Historic Preservation Design Review

June 25, 2015

HP-15-11, 34 N. Main St. (City)

Request: Façade renovations to include new wood-framed windows, brick pavers, front awnings, new rear doors and wood trellis with metal awning.

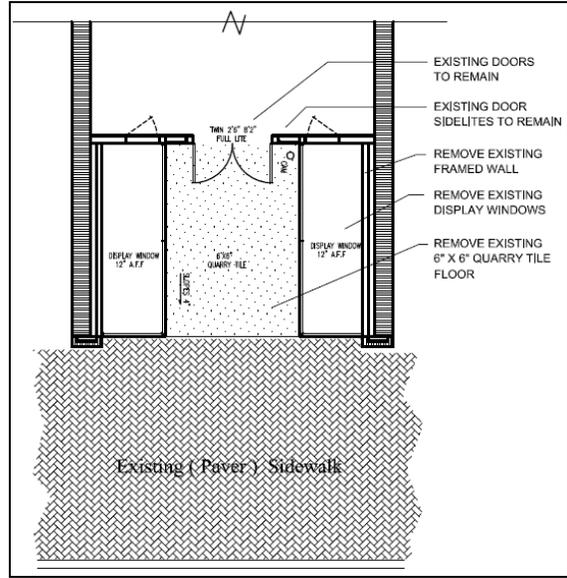
working down, the façade has nesting semi-elliptical brick arches above a brick circle. There are paired windows topped by semi-elliptical arches—the second story windows are replacement windows installed at some point after 1985 and do not retain the original 1/1 sash configuration. In addition, the façade retains a leaded glass clearstory over the recessed storefront entrance—it is likely that this element remains from the original façade as 1985 photographs show the clearstory covered over by signage.

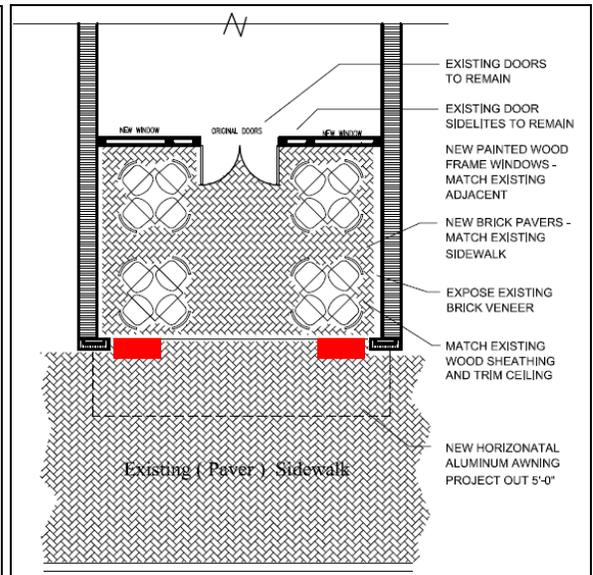
Front Entrance: The applicant proposes to remove the existing storefront to create covered outdoor dining that is accessible from N. Main St.

- Remove existing storefront display windows and damaged brick bulkheads but retain existing entry door and sidelites;
- Remove 6" x 6" quarry tile floor;
- Remove existing framed walls on the interior walls.

- Add new windows and wooden bulkheads on each side of the retained entry door and sidelites;
- Add new horizontal aluminum awning that projects 5 ft. over the sidewalk (pictured below left);
- Extend brick pavers from the sidewalks into the area underneath the opening.
- Add planters to the front of the outdoor dining area in the locations indicated in red on the previous page to match the adjacent Main Room entry and to help define the edge between the public sidewalk and the outdoor seating area (Pictured below right).

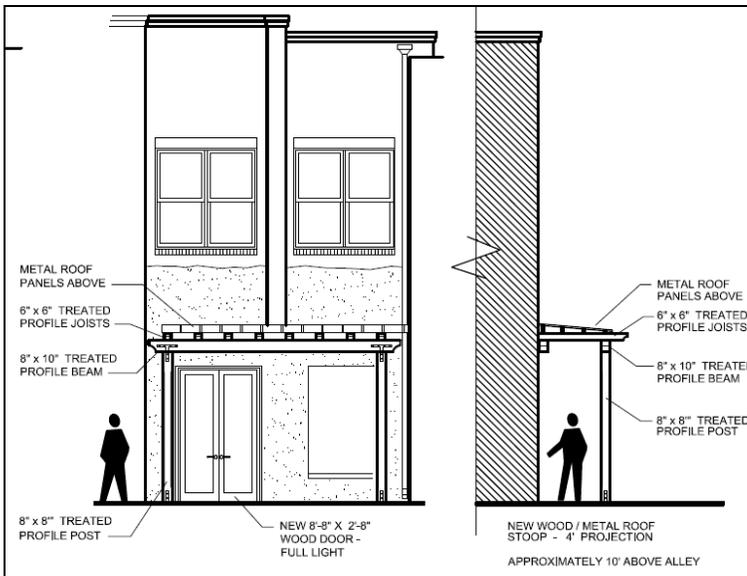
Rear Entrance: Replace the existing green security door that accesses the “Alleyway” with a new door and entrance cover. Existing conditions shown below.
